FIELD INSPECTION

Project Name:	Mountain Valley Pipeline	Inspector:	Marshall Willis
Inspection Date:	Tuesday, February 26, 2019	Project Contact:	Brian Clauto
Spread I: Franklin County	STA 13848+50 – 13942+00	Weather (Wet/Dry/Rain):	Dry

FIELD INSPECTION PHOTO LOG

Fig. 1: STA 13942+00 – No diversion for CWD.

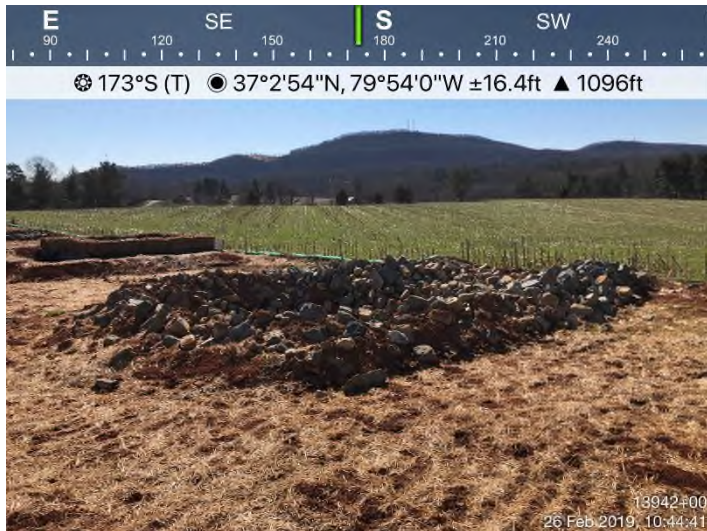
- Streams / wetlands inspected included: S-II2, W-CD5, S-CD6, S-C17 and W-CD6.
- Sediment off ROW at STA 13850+90 – item on punch-list, awaiting landowner approval.
- No diversion berm for CWD as STA 13942+00.
- No diversion berm for CWD as STA 13943+00.
- CWD pool unable to drain at STA 13910+00.
- SSF undermined at STA 13907+75.
- SSF needs maintenance at STA 13907+00.
- CFS needed to direct discharge into sump at STA 13901+00.
- CFS needs maintenance at STA 13881+00.
- Sediment off ROW at STA 13860+90 – item on punch-list, awaiting landowner approval.
- CFS needs maintenance at STA 13860+94.

Recommended Corrective Action: Maintain and install all controls per the approved plan and specs.
